LiDAR Quality Assessment Report

Materials Received:	Project Type: NSDI Agreement				
1/6/2012	3 //				
	Project Description:				
Project ID:	Sibley County is one of the 25 counties as part of the Minnesota River Basin - Phase				
MN_MNRiverBasin-Phase1_2010					
	1 lidar project.				
Project Alias(es):					
MN_SibleyCo_2010	Year of Collection: 2010

Lot 21 of 25 lots.

Bare-Earth DEM Anomalies, Errors, Other Issues

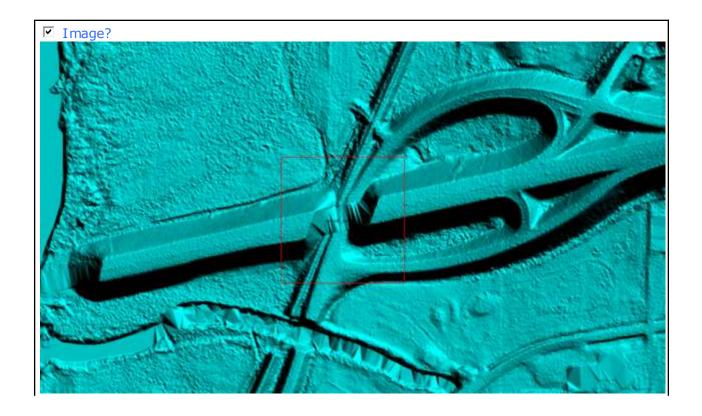
bridge_saddle: This is not being noted as an error. The bridge artifacts were covered with a patch in the DEM only by NGTOC personnel.
